Groundwater Application Review Summary Form

Application # G- 18600 GW Reviewer Ber Scandella, Dennis Orlanski Date Review Completed: 4117118
Summary of GW Availability and Injury Review:
[] Groundwater for the proposed use is either over appropriated, will not likely be available in the amounts requested without injury to prior water rights, OR will not likely be available within the capacity of the groundwater resource per Section B of the attached review form.
Summary of Potential for Substantial Interference Review:
[There is the potential for substantial interference per Section C of the attached review form.
Summary of Well Construction Assessment:
[] The well does not appear to meet current well construction standards per Section D of the attached review form. Route through Well Construction and Compliance Section.

Review of Water Right Application G-18600

Figure 1: Water-Level Trends in Nearby Wells

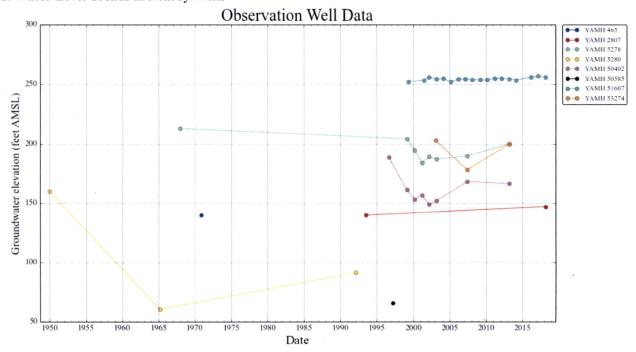
Nearby well logs show typical yields of <50 gpm, with a median of 21 gpm out of 79 wells. The well log for YAMH 50585 shows a yield of 75 gpm on an air test, but it is unlikely that the well can support the requested rate of 200 gpm. Water level data from nearby basalt wells with similar water-bearing zones and static water level elevations show relatively stable trends (See Figure 1), suggesting that the resource is not yet over-appropriated. However, condition 7I (Willamette Basin Basalt Groundwater Condition) is recommended to monitor the resource.
